Technical Bulletin

ICOM

IC-735

HF ALL BAND TRANSCEIVER
GJ36783

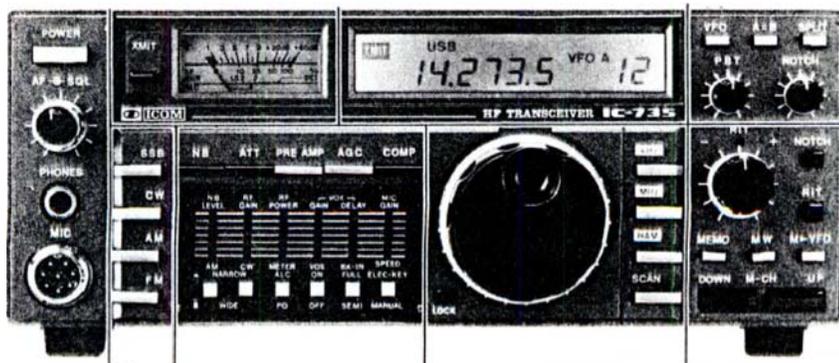
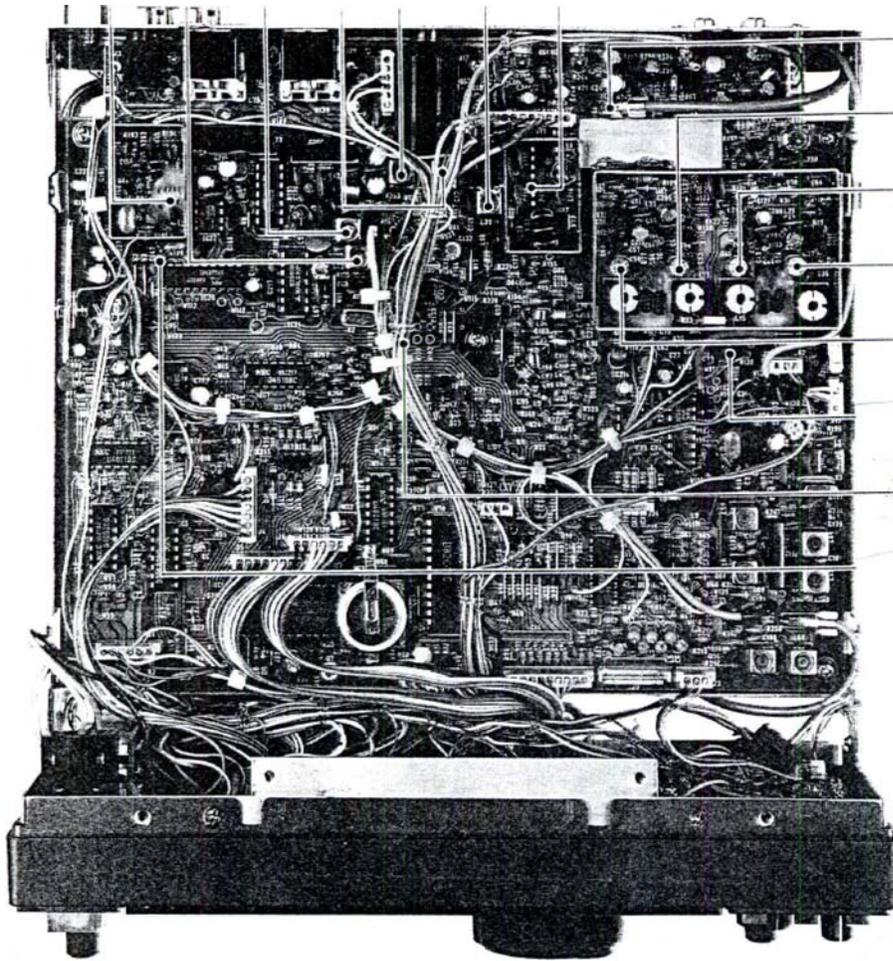
Distorted receive and/or transmit audio on one or more bands. Distortion may be temperature related. Single sideband audio sounds "raspy" or "rough". Selected frequency may show instability.

The trimmer caps in the PL unit (HPL VCO), and Reference Oscillator unit may have aged and changed values.

[PL] UNIT BOARD

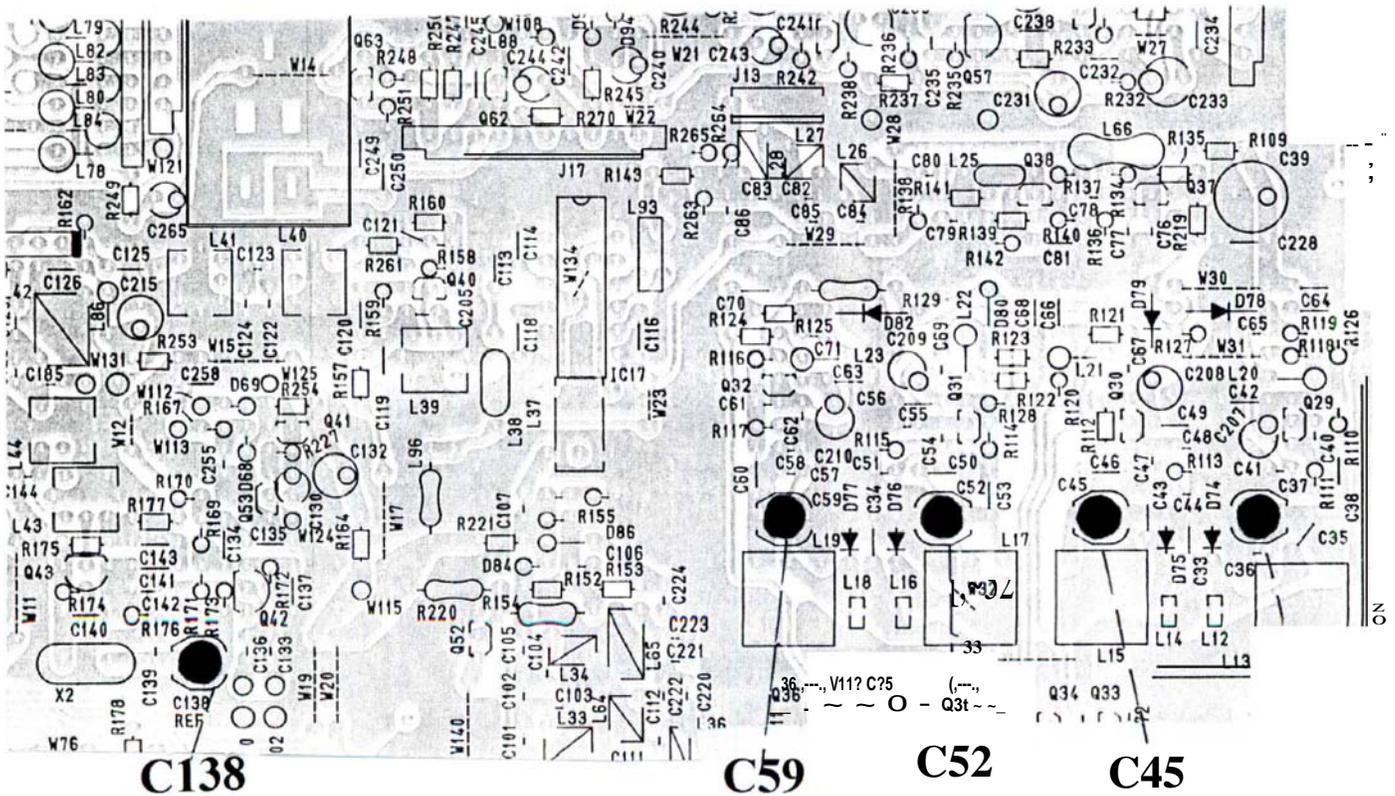
Replace the following trimmer caps:

C37	10pf	with an Icom # 4610000110 12pf unit vco cap (white)
C45	10pf	with an Icom # 4610000110 12pf unit vco cap (white)
C52	6pf	with an Icom # 4610000100 6pf unit vco cap (red)
C59	6pf	with an Icom # 4610000100 6pf unit vco cap (red)
C138	6pf	with an Icom # 4610000100 6pf unit REF osc (red)

The replacement trimmer caps are long-life ceramics. A partial realignment will be required after these trimmers are replaced. See Service Manual for procedure.
